Technical Bulletin

** FOR IMMEDIATE ATTENTION **	
SUBJECT:	ALL IAC TOOL TROLLEYS, LT LIGHT BARS AND LT BAR SUPPORTS WILL BE PAINTED TEXTURED BLACK
DISTRIBUTION:	IAC Employees, Reps & Dealers
EFFECTIVE DATE:	February 1, 2023

PRODUCT CHANGE	
PRODUCTS AFFECTED:	Dimension 4, Multi-Task System (MTS), Multi-Flex Bench (MFB), EZE Reach, Packaging Station
DESCRIPTION:	Previously painted to match the color of the workbench and upright support frame, <u>all</u> IAC tool trolleys will now be painted Textured Black. Additionally, all LT light fixture bars and LT bar supports are now painted Textured Black.
ADDITIONAL INFO:	See pages 2 and 3 for photos and a list of part numbers affected.

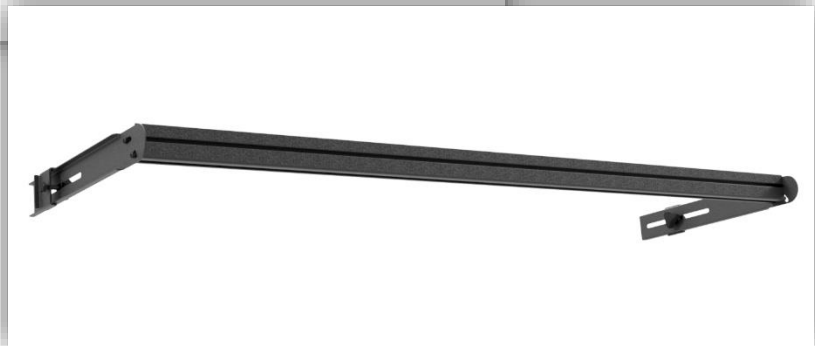
Our Dimension 4 and EZE Reach Tool Trolleys were previously painted to match the workbench. **All are painted Textured Black now.**

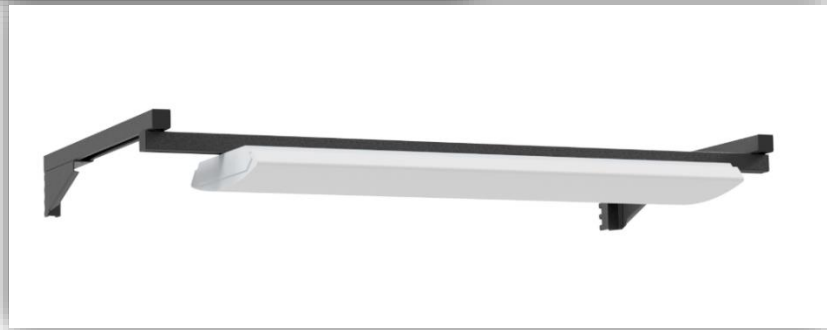
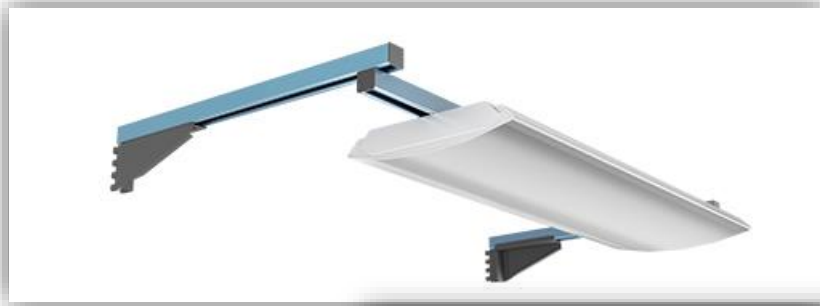
Our MTS, Packaging Station, and MFB LT Light hanging bars and LT bar supports were previously painted to match the workbench.

All are painted Textured Black now.
